ADDENDUM 2

12" Public Sewer Extension Phase 3 Project Number: 2020-007B Bid No. 2644

October 29, 2024

C1-08

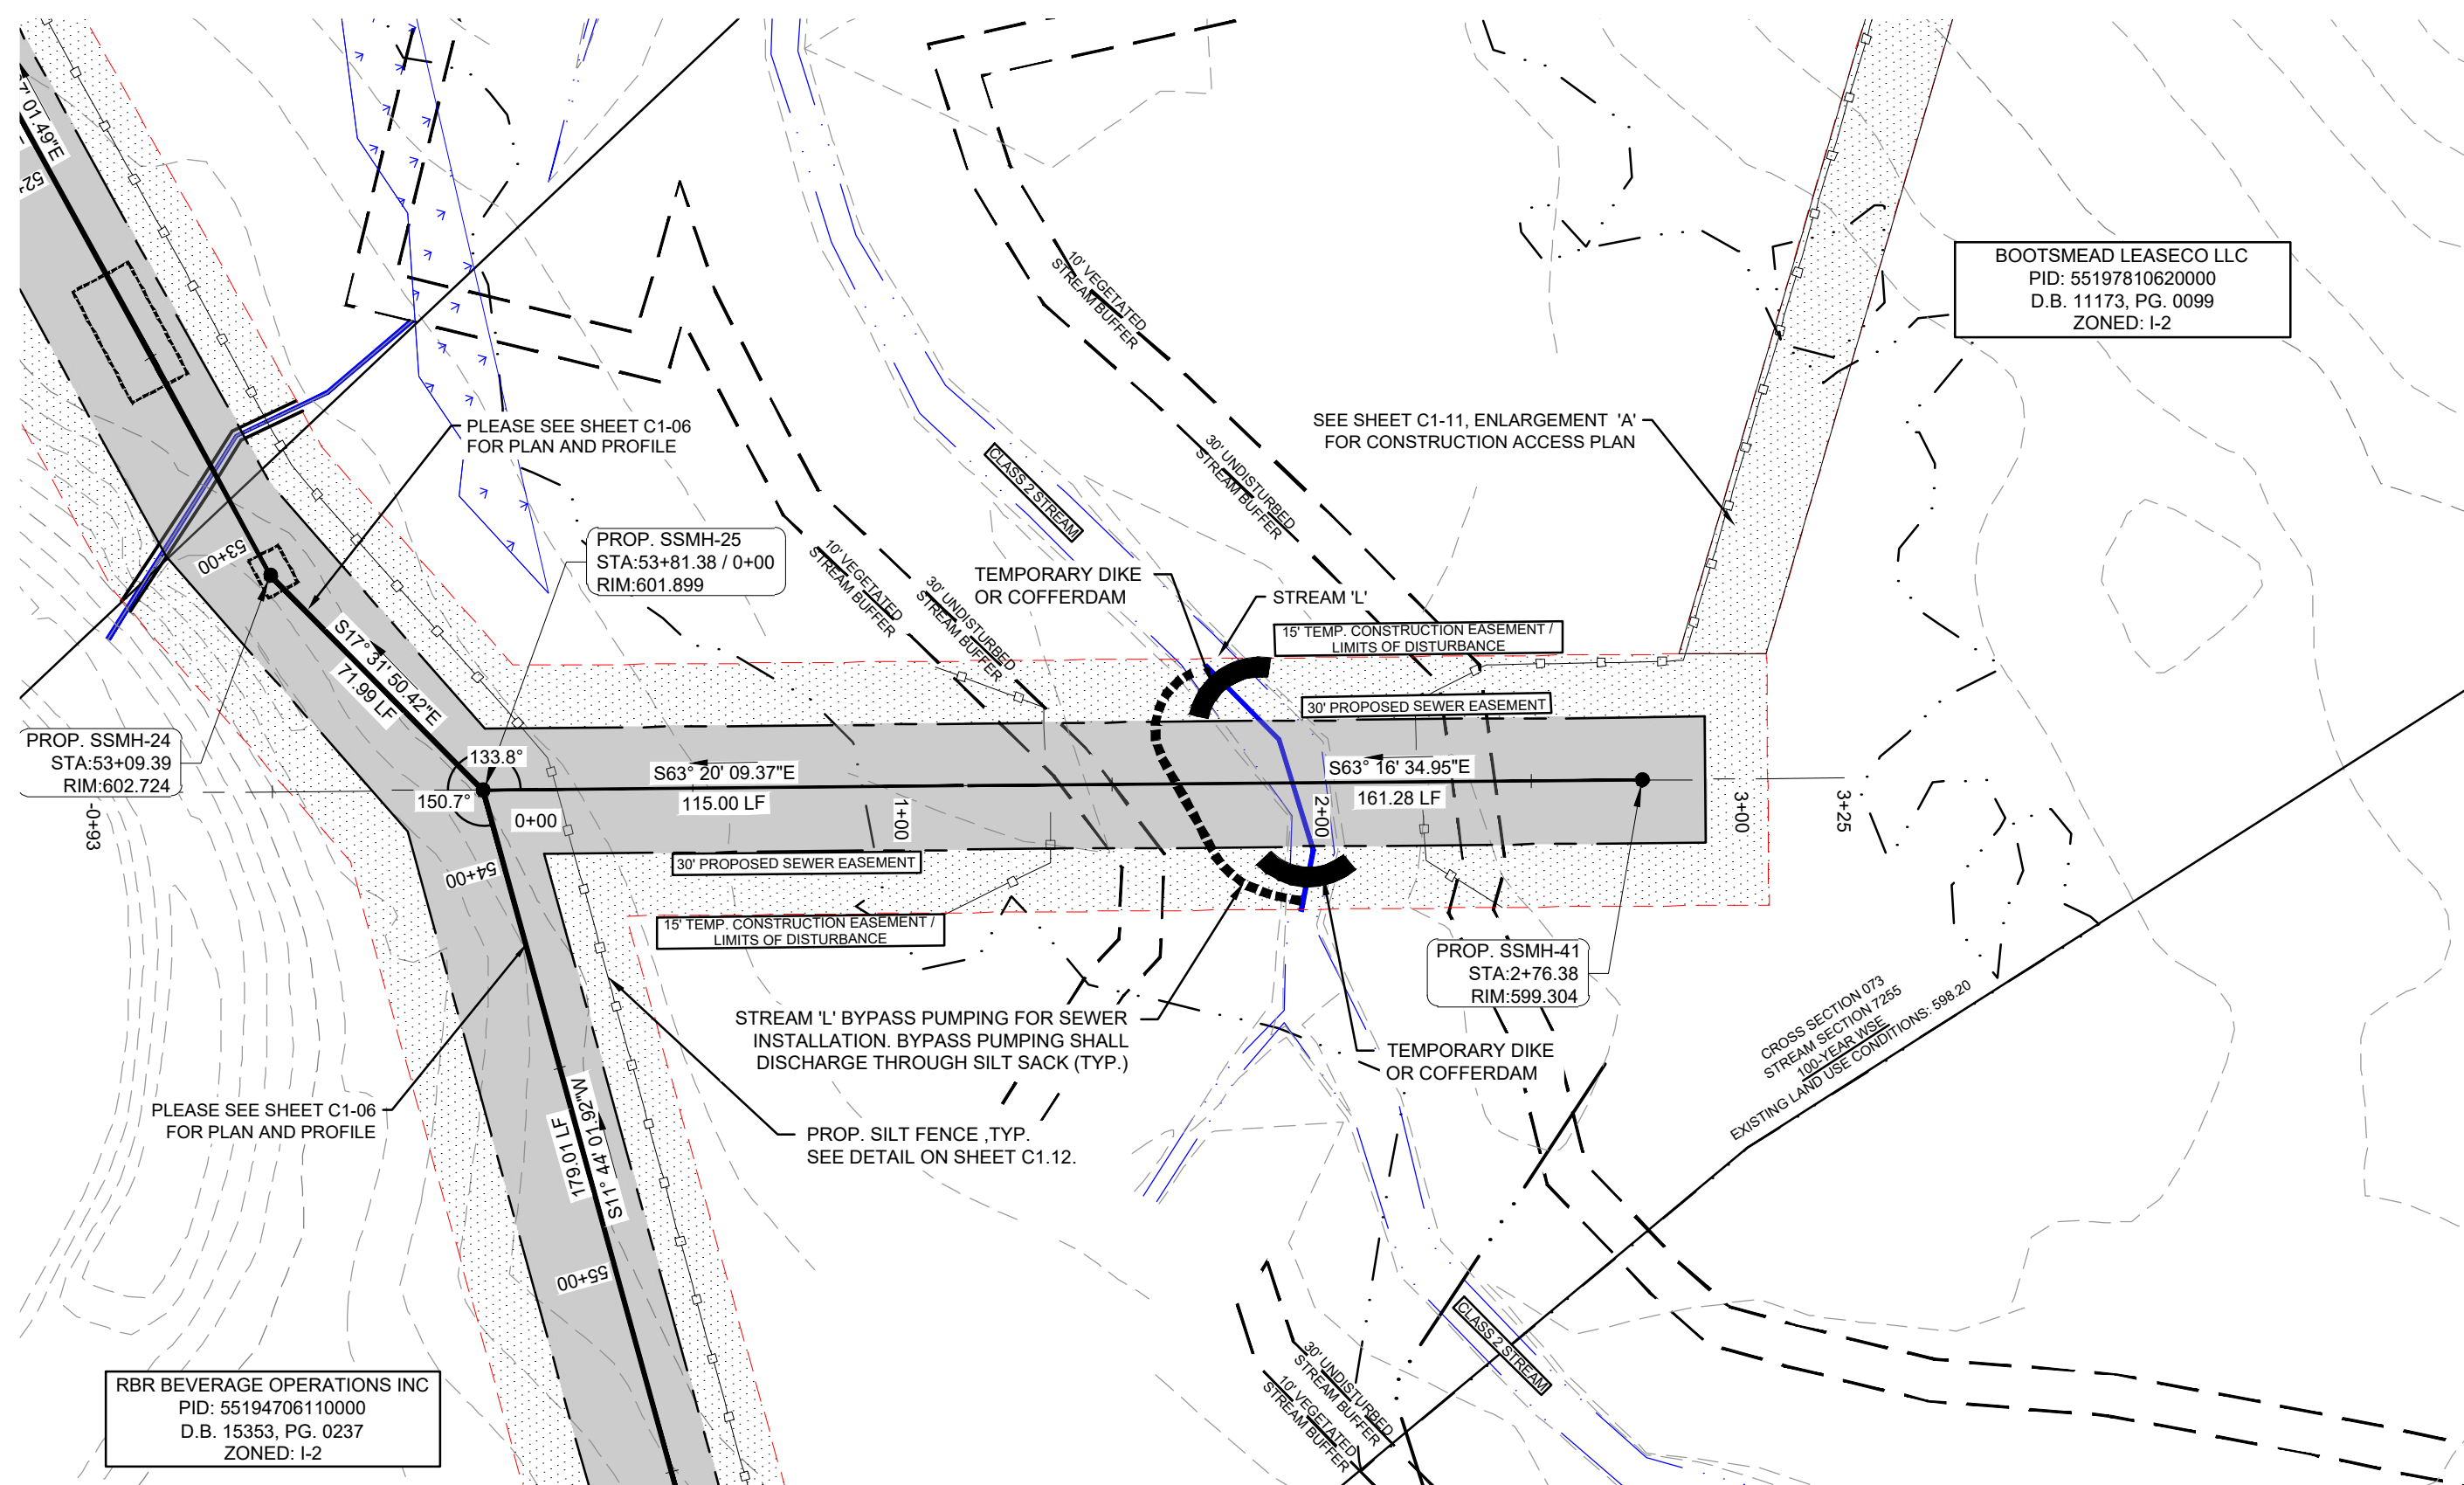
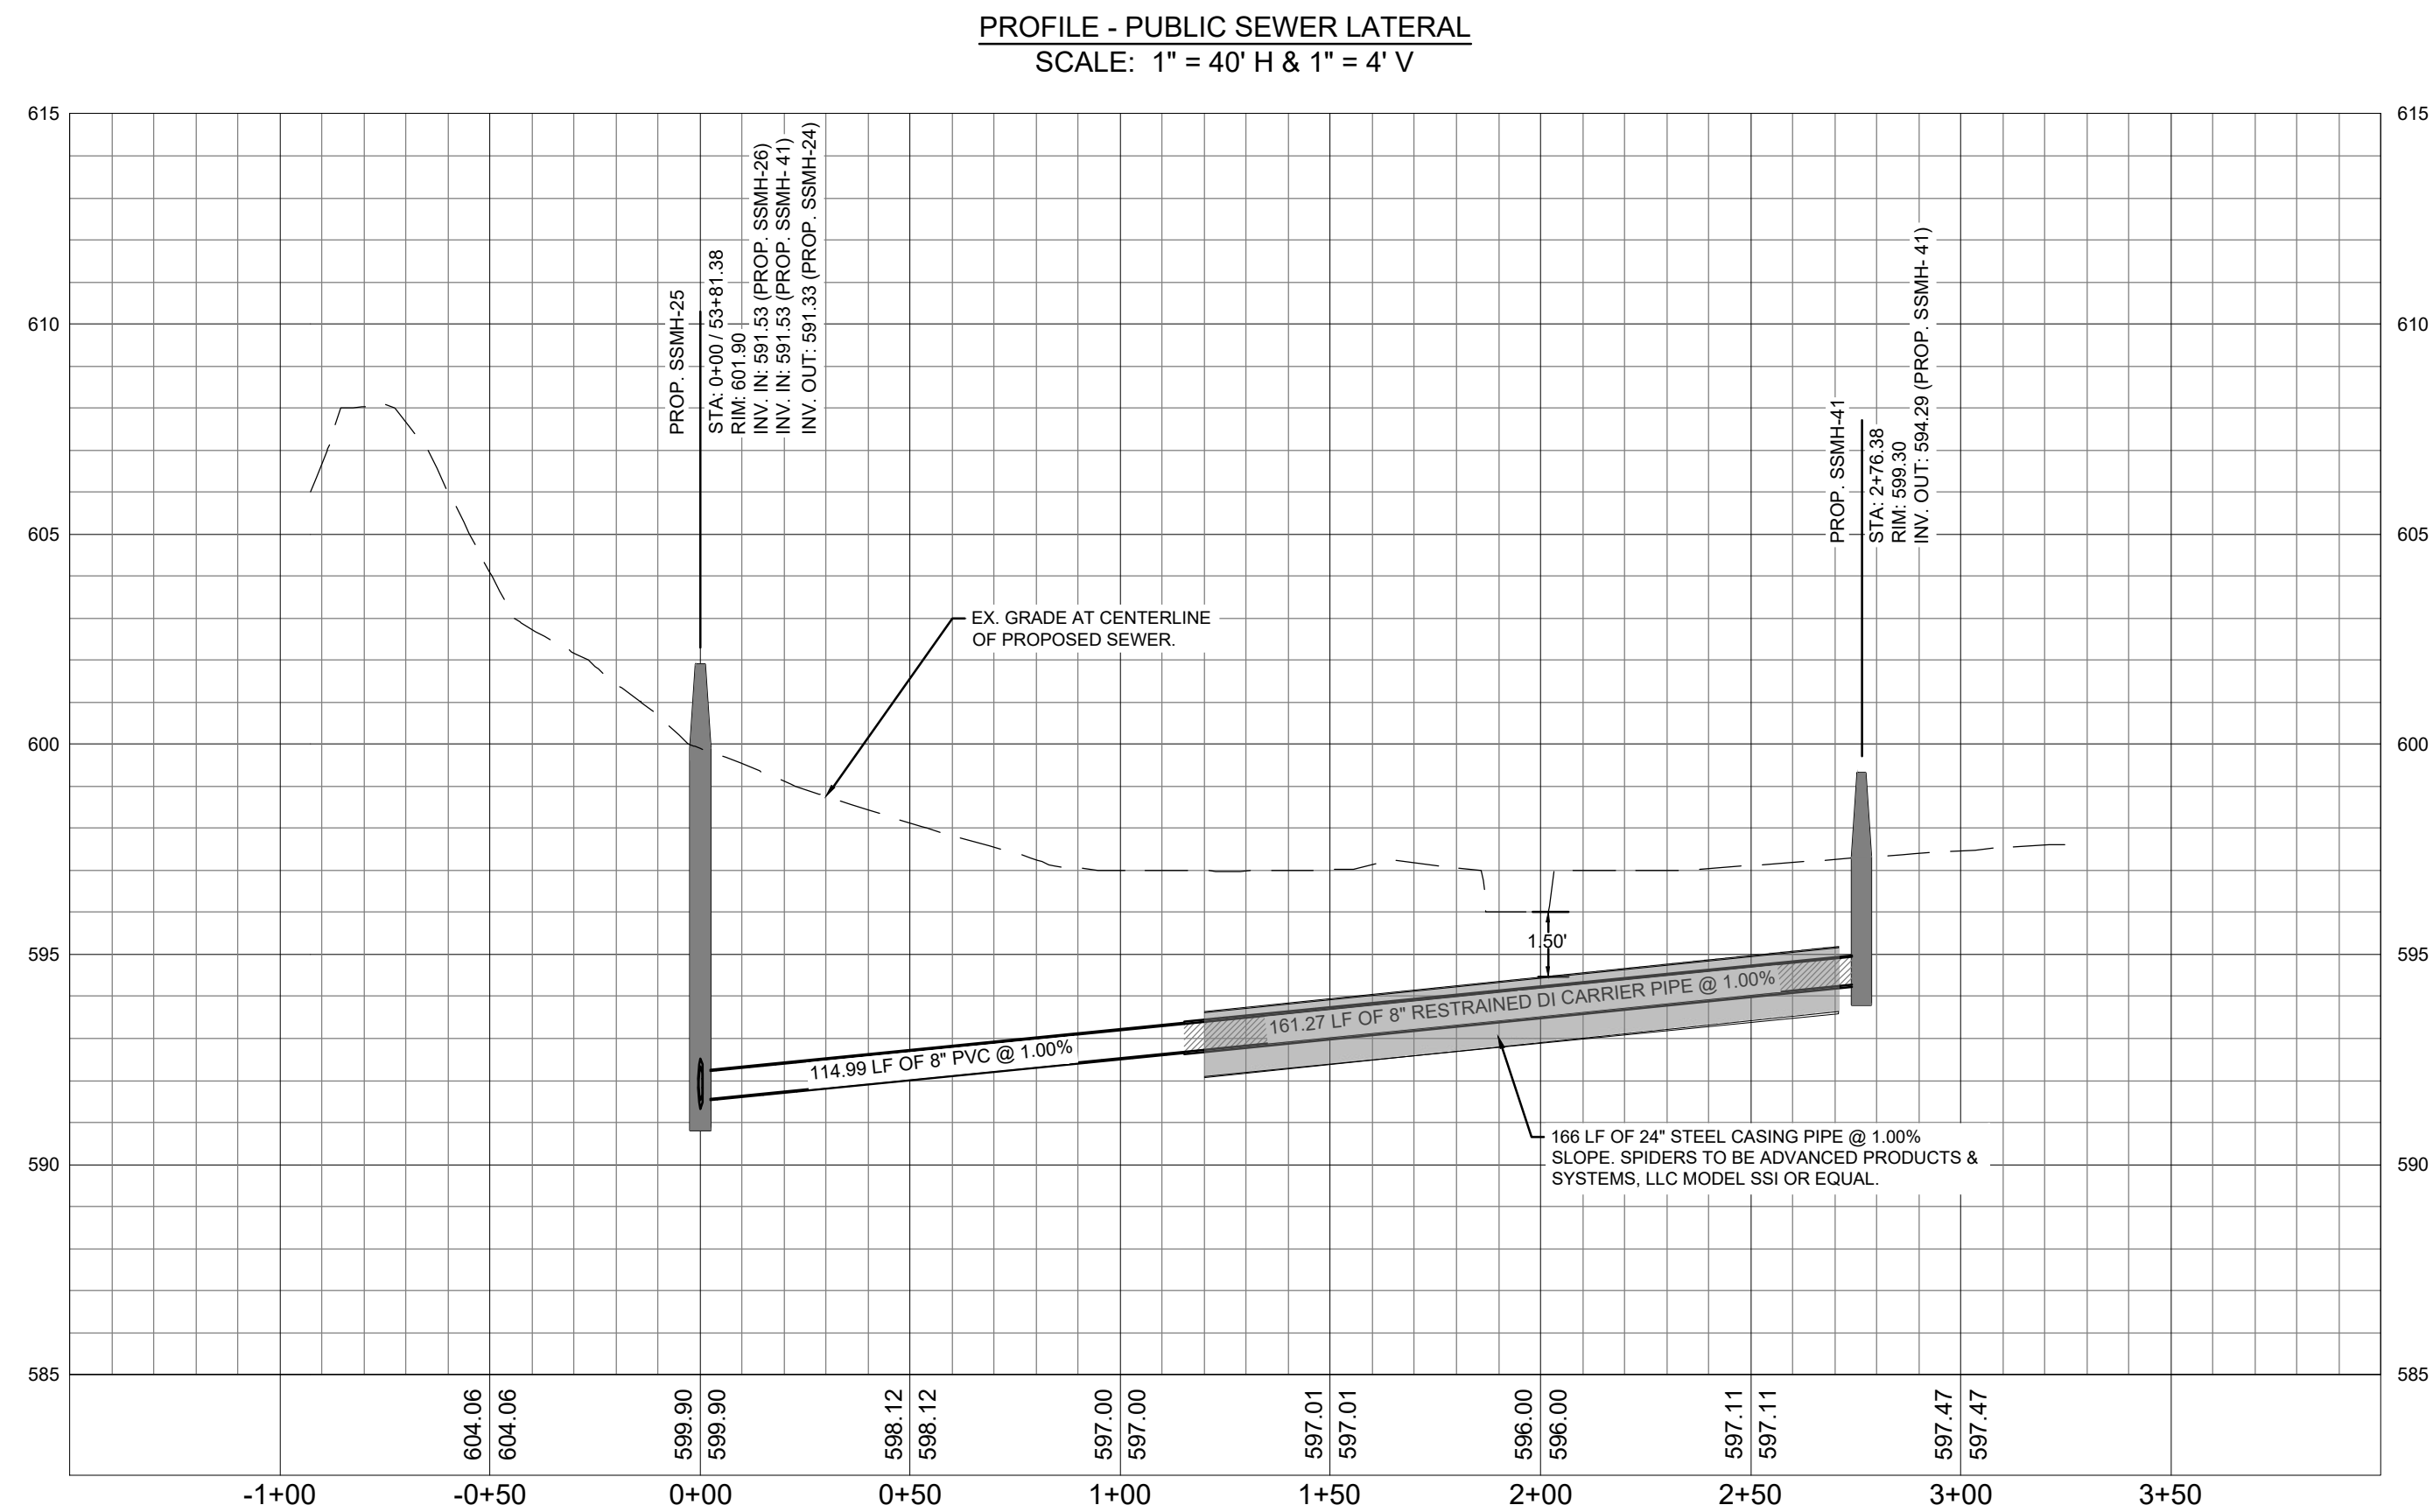
3. Can you specify what type of C900 will be required in the wetlands? *DR-14.*
4. The City of Concord detail for stream crossings shows encasement pipe for crossings. There are several stream crossings shown on the plan and profile.

- a. The crossing at Sta. 35+50 does not show any encasement pipe – will encasement pipe be required? *Yes.*
 - b. The crossing at Sta. 70+50 does not show any encasement pipe – will encasement pipe be required? *Yes.*
